REMARKS

Serial Number 10/822,666

ANNOTATED MARKED-UP DRAWING SHEET

FIG. 9

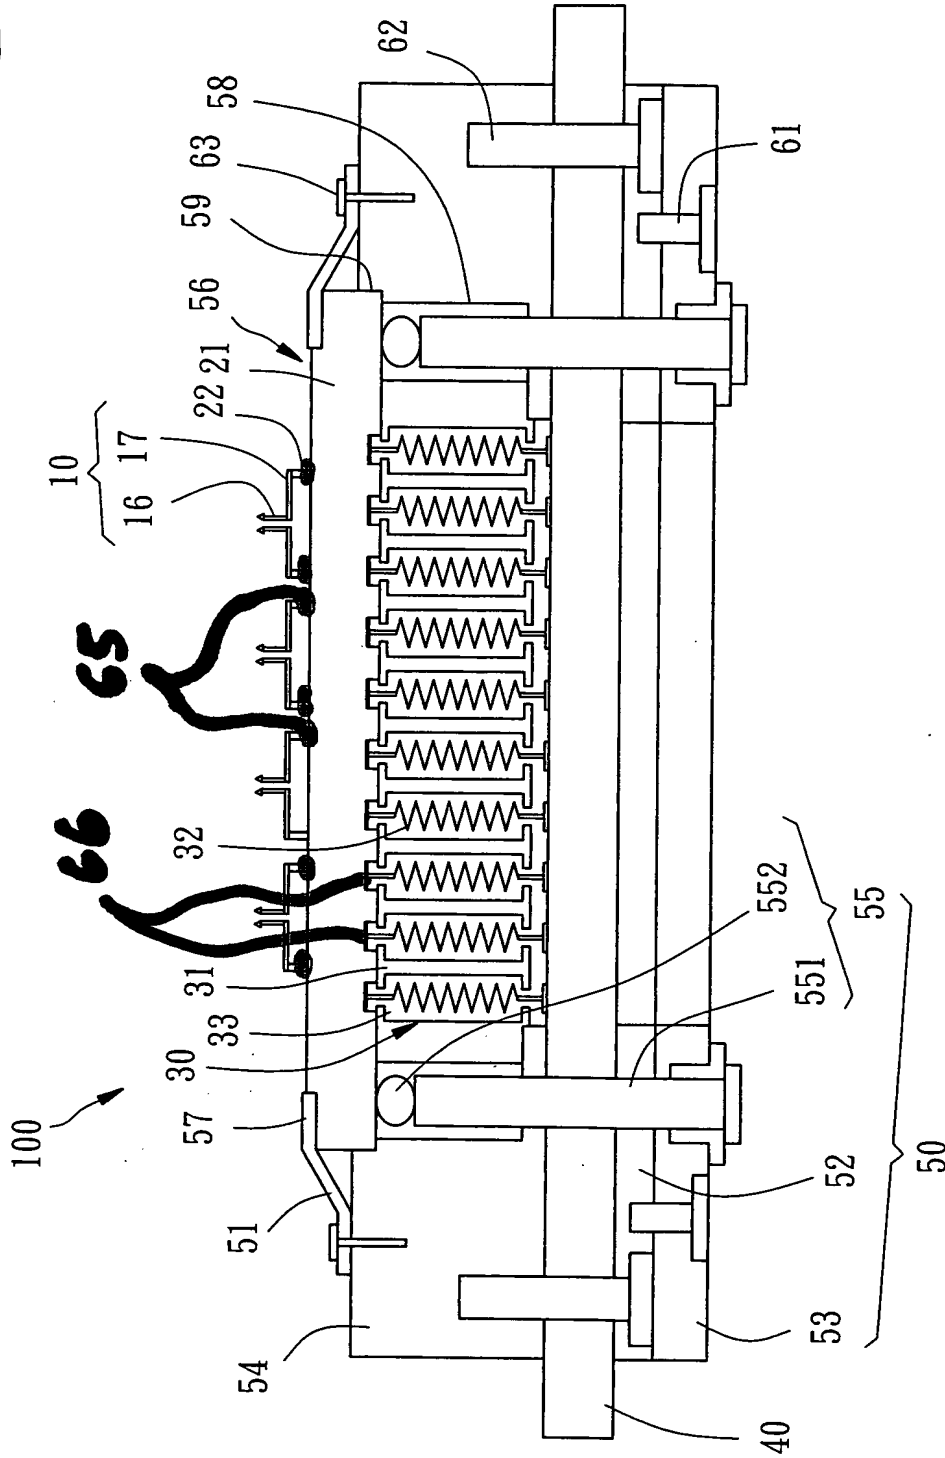
Fig. 9 has been amended to show the topside contacts described on pages 5 and 6 of the original specification, and to add reference numerals 65 and 66 to respectively indicate the **top and bottom side contacts**. Pages 5 and 6 of the specification has been amended to add reference numerals 65 and 66.

It is respectfully noted that the amendments to the drawings consist of adding lines to the bases of probe holders 22 to indicate the top side contact, and adding corresponding reference numerals. Lines 4-8 specifically describes probe holders 22 as being on the **topside contacts**, and therefore the addition of lines indicating the contacts to the drawings, and corresponding reference numerals 65 to the drawings and specification, does **not** represent **new matter**. The **bottom side contacts** are already shown, and therefore the addition of reference numerals 66 to the drawings and specification also does **not** represent **new matter**.
